# Access Compliance Report

## Public Rights-of-Way

Intersection ID: N/A	Main Street: NEW_FASHION_WY	Cross Street: OUTLETS_BV	Location: SW
ADA ID: A5DAF069799C	Ramp Type: Perp	Initial Pass/Fail: Fail	Overall Compliance: No
Severity Score: 33.75			
Codes/Mitigation Info/Possible Solution		Field Measurements/Component Compliance

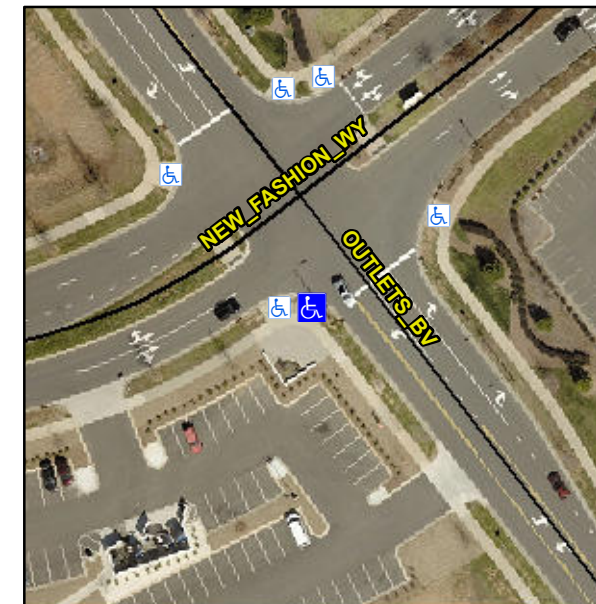
**R304.5.1, R304.2.2, R304.5.3**

Compliance	Description	Data	Compliance	Description	Data
N/A	Ramp Length (in)	93.5	No	Ramp Slope (%)	8.6
No	Ramp Width (in)	47.0	No	Ramp XSlope (%)	5.1
N/A	Flare Type LT	N/A	N/A	Flare Type RT	N/A
N/A	Flare Slope LT (%)	N/A	N/A	Flare Slope RT (%)	N/A
N/A	Flare Traversable LT?	N/A	N/A	Flare Traversable RT?	N/A
N/A	Landing Length (in)	N/A	N/A	DWS Provided?	N/A
N/A	Landing Width (in)	N/A	N/A	DWS Contrast?	N/A
N/A	Landing Slope (%)	N/A	N/A	DWS Length (in)	N/A
N/A	Landing X Slope (%)	N/A	N/A	DWS Full Width?	N/A
N/A	Landing Curb? (Y/N)	N/A	N/A	DWS Offset (in)	N/A
N/A	Shared Landing?	N/A			
N/A	Gutter Ponding?	N/A	N/A	Gutter Slope (%)	N/A
N/A	Gutter Lip Ht (in)	N/A	N/A	Gutter X Slope (%)	N/A
N/A	Painted X Walk1?	No	N/A	Painted X Walk2?	N/A
	X Walk 1 Direction	To NE		X Walk 2 Direction	N/A
N/A	X Walk 1 Width (in)	N/A	N/A	X Walk 2 Width (in)	N/A
	X Walk 1 Slope (%)	3.5		X Walk 2 Slope (%)	N/A
	X Walk 1 X Slope (%)	0.3		X Walk 2 X Slope (%)	N/A

**Remove & Replace Entire Ramp.**
